Re: Mining of Entries and the 1 Right 5 West and 2 Right 5 West Panels, Sufco Mine, Permit Number C/041/0002, Canyon Fuel Company, LLC

# APPLICATION FOR COAL PERMIT PROCESSING

**Title:** Mining of Entries and the 1 Right 5 West and 2 Right 5 West Panels

**UPPER HIAWATHA MINE PLAN  
5 YEAR PROJECTION**

PEN. NO.	DATE	SCALE	DATE	DRAWN BY	ENGINEER	CHECKED BY	SHEET NO.
9394094-8200	3/5/2015	1" = 2,000'	3/5/2015	B.D.H./T.R.B.	J.D.B.	Y.M.	PLATE 5-7v10
DWT SEC.	PROJECT NUMBER	FILE NAME					
###	###	H:\DRAWINGS\MRP\PLATES\PLATE 5-7v10.dwg

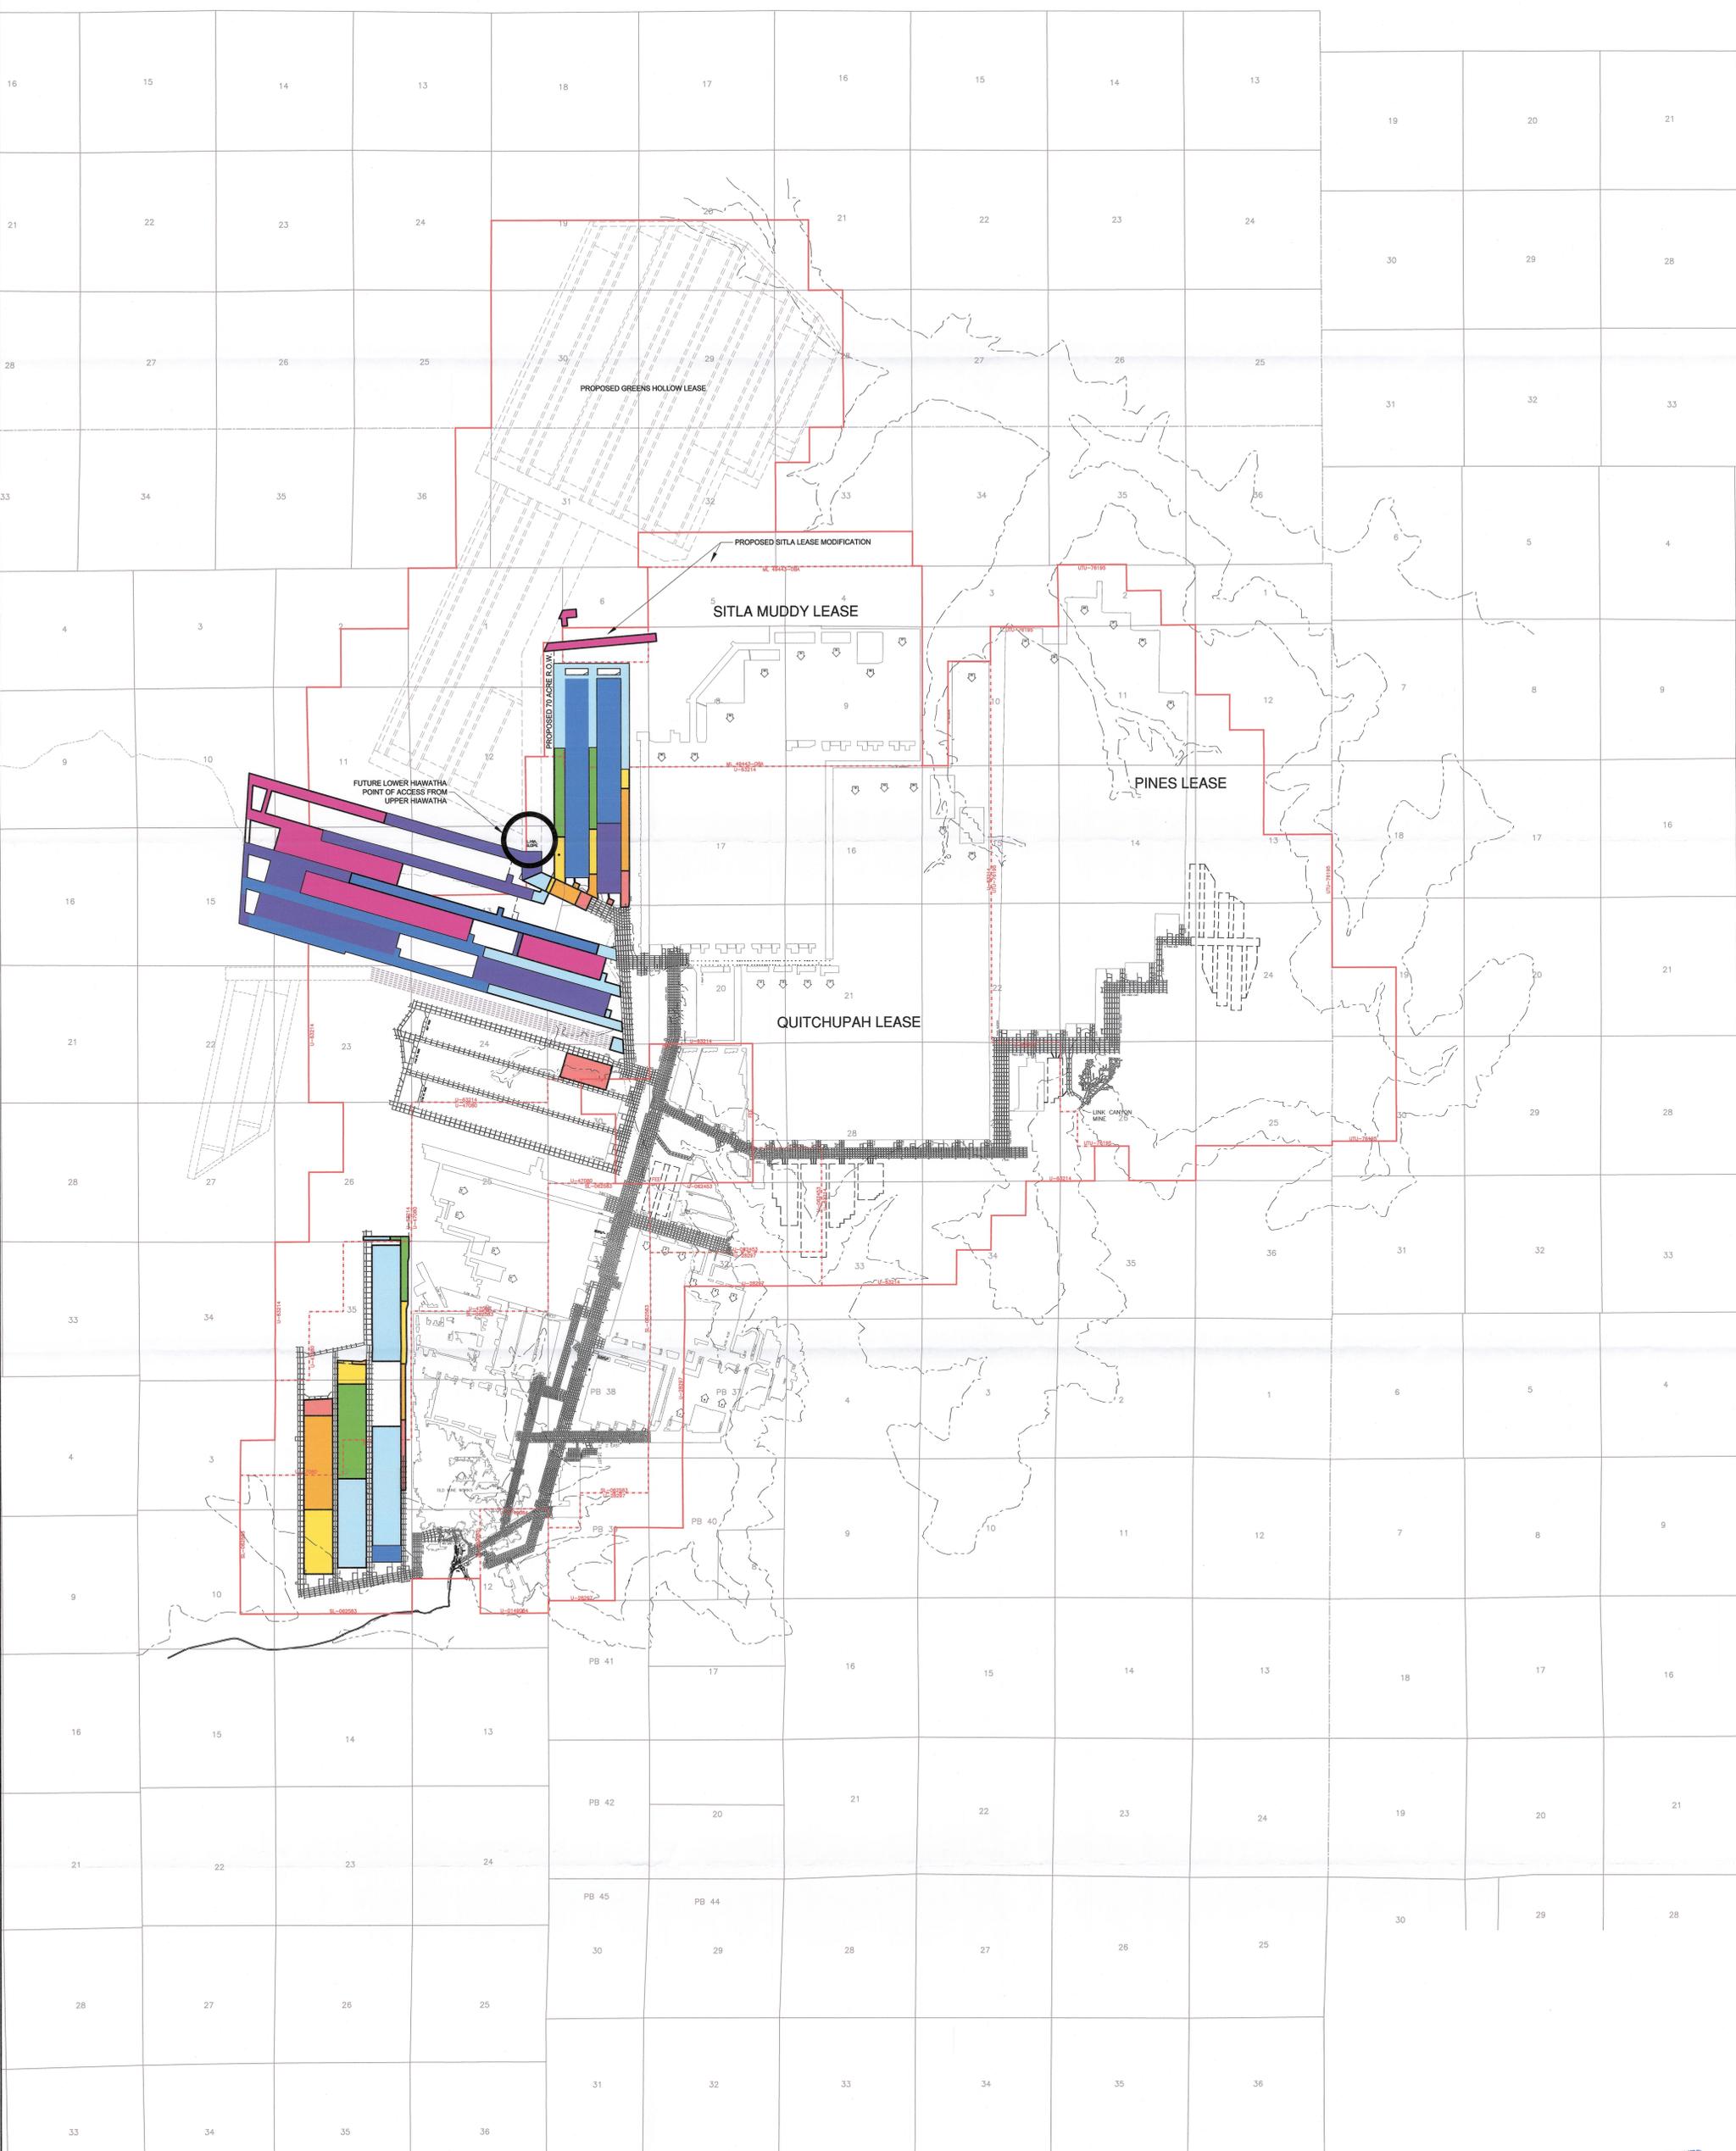
Please find enclosed with this letter an amendment to the Sufco Mine Permit to outline past mining and the projected mining for the next five years. The 1 Right and 2 Right Panels of 5 West run north and south are shown crossing leases U-63214 and ML 49443-OBA. These panels are primarily within the boundaries of existing leases and have appeared before on maps as areas designated for mining. The enclosed map designates the timing for mining these panels. The timing shows that only first mining will occur within the remainder of 2015 and approximately the first half of 2016. Longwall mining will follow the completion of the first mining as shown on Plate 5-7.

There are segments of these panel which extend outside the lease boundaries but as stated on Plate 5-7, "Any projected mining shown beyond existing lease boundary lines is subject to future lease modifications and approvals." As previously discussed with Division personnel, Sufco is currently in the process of securing the areas labeled as "proposed" on the enclosed Plate 5-7. Sufco has no intent to mine outside their existing leased boundaries, until the modifications are leased from their respective agencies and approved by the Division.

REVISIONS				
NO.	DATE	REQ. BY	DWG. BY	REMARKS
1	01/26/2015	M.L.D.	B.D.H.	
2	05/08/2015	M.L.D.	K.B.S.	
3	06/13/2015	M.L.D.	K.B.S.	
4	06/13/2015	M.L.D.	K.B.S.	
5	06/13/2015	M.L.D.	K.B.S.	
6	06/13/2015	M.L.D.	K.B.S.	
7	06/26/2015	M.L.D.	K.B.S.	
8	06/26/2015	M.L.D.	K.B.S.	
9	06/26/2015	M.L.D.	K.B.S.	
10	03/03/2015	Y.M.	T.R.B.	ADDED TO ACRE B.O.W. AREA FOR 5 WEST
